MT. HOLLY-HUNTERSVILLE ROAD
025-153-15

MECKLENBURG COUNTY

A pre-preliminary investigation of soils and topography was conducted on the tract (parcel 025-153-15) located on Mt. Holly-Huntersville Road. A soils map of the tract was prepared and a copy is enclosed.

Pre-Preliminary 025-153-15

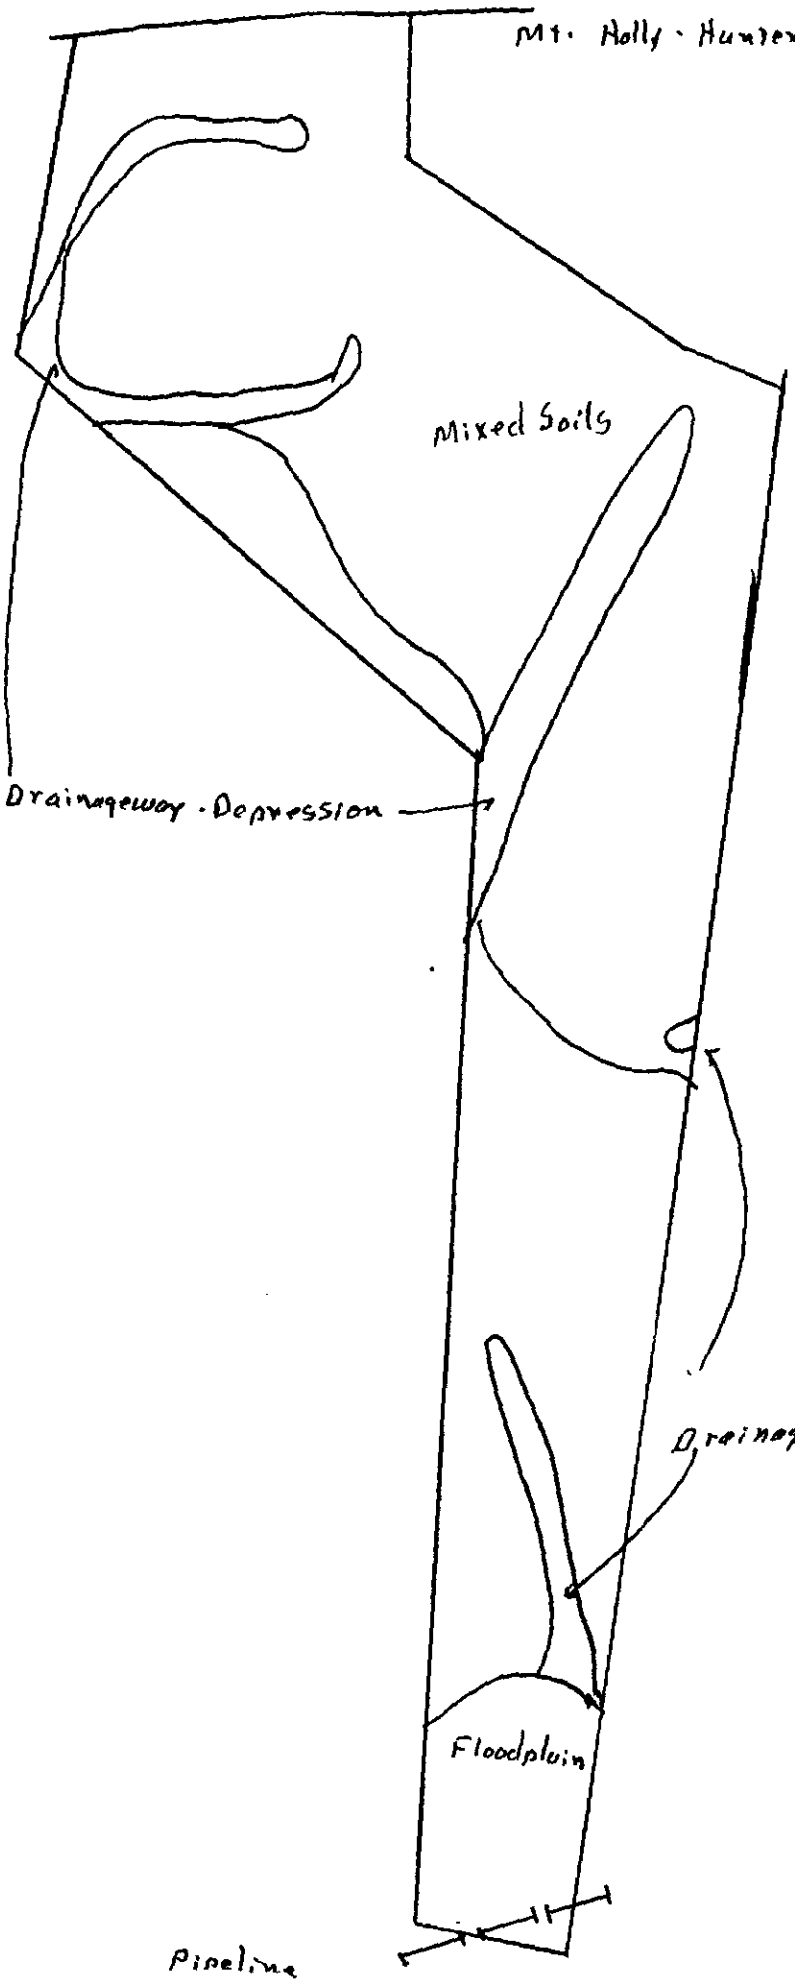
The areas shaded yellow on the enclosed map appear to be dominantly unacceptable for the installation of septic tank systems. Included are mixed soils, drainageway depression areas, and a floodplain area.

The mixed soils have expanding clay present that swells upon becoming wet, reducing soil pore space and internal water movement. These soils are generally less than thirty-six inches in depth to saprolite. Some areas with perched water less than thirty-six inches deep were observed.

The drainageway depression areas collect and channel surface runoff. These areas may have small areas of complex slopes present.

The floodplain area may be subject to some surface flooding. Indications of seasonal water tables were observed at depths of twelve inches or less.

Based on this investigation there are some areas that appear to be dominantly acceptable for the installation of septic tank systems. Please note that this report does not express or imply individual lot approval for septic tank system installation. Individual lot approval is subject in part to the satisfactory completion of an investigation of each lot. Currently, no lots are marked on the tract. Soil delineations may be subject to change pending additional investigation with established reference points. Any lots developed on the tract would require that a repair area in acceptable soils sufficient in size to accommodate a complete replacement system be available. Please contact me if there are any questions with regard to this report.
